**WESTECH ENGINEERING, INC.**  
CONSULTING ENGINEERS & PLANNERS

RE: Premier Development LLC PDA 3-18, PDA 4-18, and S 3-18

This letter is in response to PBS May 24, 2019 letter (PBS Response Letter) to Friends of Baker Creek's response to Kellington Law Groups response to PBS Report (Hydrologic Analysis of Baker Creek). Our responses are numbered in accordance to that provided in the PBS letter.

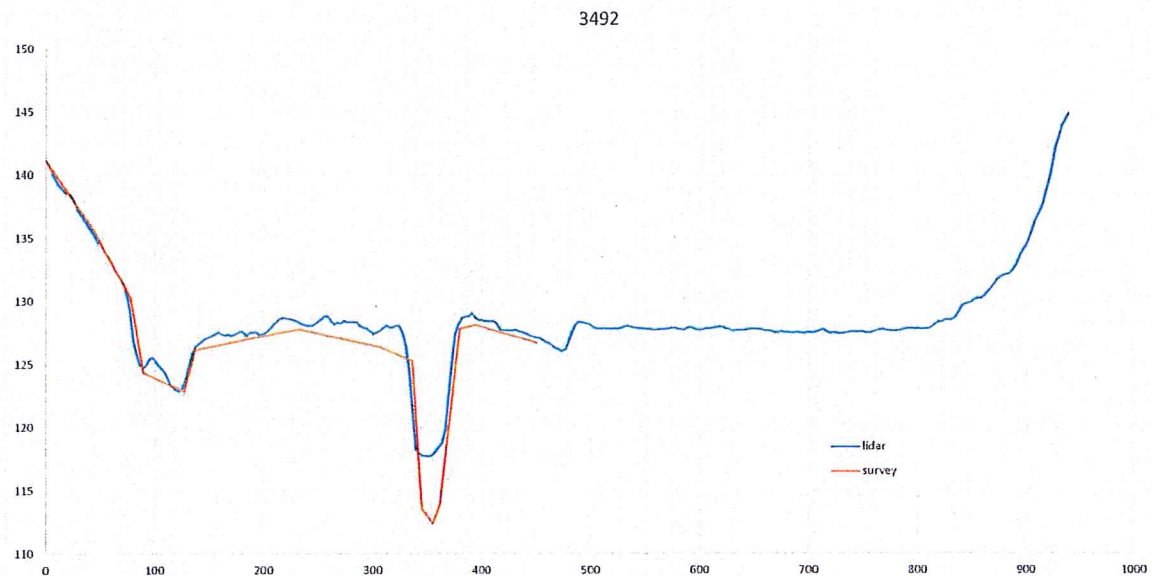
We agree that unit discharges are not the only way to evaluate the reasonableness of peak flows for a watershed and that each watershed is unique. However, FEMA uses unit discharges to help review results of a hydrologic models when used for a Flood Insurance Study to ensure the model results are reasonable.

Our primary concern was that PBS states in the last sentence on page 9 of their May 2019 report that "Of the modeled calibration watersheds, Butte Creek and Tualatin Creek watersheds are the most similar in composition to the Baker Creek drainage area." Yet the unit discharges for Butte Creek and Tualatin River are 154 cfs/mi<sup>2</sup> and 141 cfs/mi<sup>2</sup>, respectively while the unit discharge for Scoggins Creek (assumed to be less similar in composition to Baker Creek) is 230 cfs/mi<sup>2</sup>. They do not explain in their report or their rebuttal the justification for the significantly higher unit discharge of 239 cfs/mi<sup>2</sup> for Baker Creek when compared to the two watersheds that are most similar in composition. The comparison to other watersheds in western Oregon shown in the PBS Response Letter makes it appear that their model results are in the ballpark. However, since they are using a Log-Log scale plot for their comparison, the ballpark is rather large.
